**TO: PLANNING COMMISSION**

**SUBJECT: SUPPLEMENTAL STAFF REPORT REGARDING CONSOLIDATED  
DESIGN REVIEW, SITE PLAN REVIEW, REPLAT, PROPERTY LINE  
ADJUSTMENT, ADJUSTMENT, AND DRIVEWAY APPROACH PERMIT  
CASE NO. DR-SPR-REP-PLA-ADJ-DAP18-08; FOR PROEPRTY  
LOCATED IN THE 2100 TO 2300 BLOCKS OF LINDBURG ROAD SE AND  
STRONG ROAD SE**

**(AMANDA APPLICATION NOS. 18-115576-DR; 18-115573-RP; 18-  
113652-LD; 18-123456-LD; 18-115574-ZO; 18-115575-ZO)**

**Figure 1** Drainage Basins Located Upstream of the Subject Site

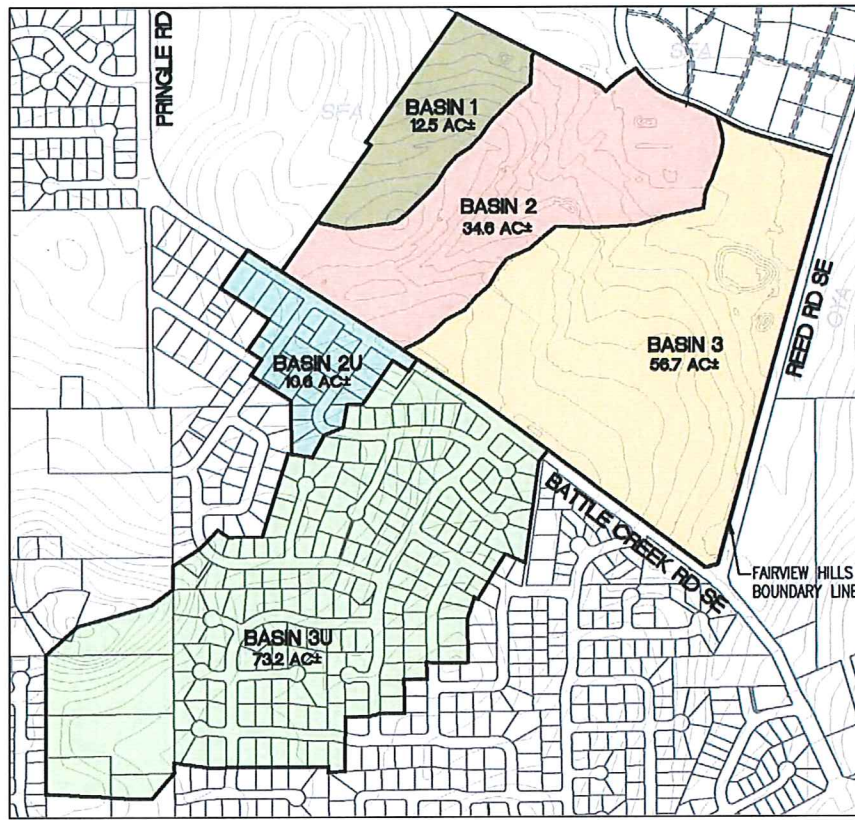
- c. The subject property receives stormwater runoff from approximately 187 acres of developed/developable land located upstream from this site and within the City. Given the significant amount of runoff that must be accommodated and the likelihood that acceptable future mitigation strategies could mandate the reconfiguration of certain elements of the current proposal, we request that a drainage analysis be completed as a condition of approval for this project. A general drainage plan exhibit from the Fairview Hills Refinement plan is included in Figure 1, below.

**Staff Response:** In order to ensure adequate provision of stormwater infrastructure for development within the *Fairview Refinement Plan II* refinement plan, a condition of approval was placed on the amended refinement plan in 2016 requiring all stormwater facilities to meet the minimum requirements of SRC Chapter 71. Based on this requirement, the Public Works Department has recommended a condition of approval for the site plan review application (Condition No. 15) requiring the design and construction of a storm drainage system at the time of development in compliance with SRC Chapter 71 that includes stormwater facilities required to serve upstream properties pursuant to Public Works Design Standards (PWDS) 4.2.

Conformance with this requirement ensures the proposed development will include a stormwater management system sufficient to address on-site and upstream demands.
